IOGP S-700, Supplementary Specification to API Standard 671 for Special-purpose Couplings, Second Edition, April 2024

ADDENDUM 1

This addendum (Version 2.01) replaces Edition 2.0 published in April 2024.

Figure L.1 — Coupling Direction of Rotation and Power Flow

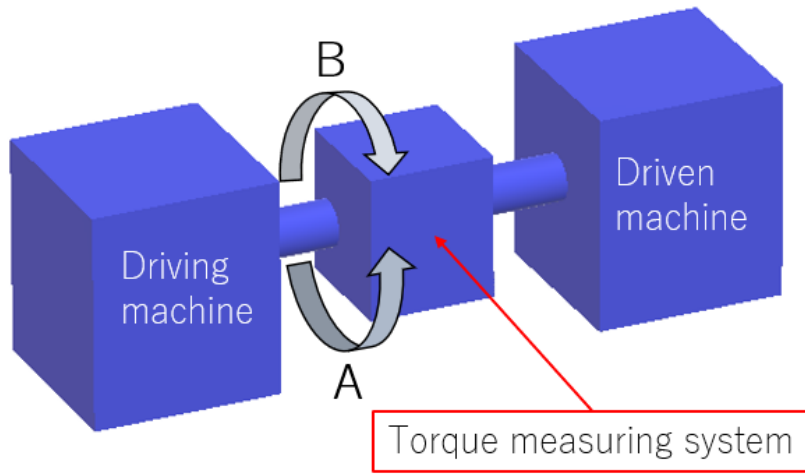
Add to list item e)

in accordance with Figure L.1

Add new Figure L.1
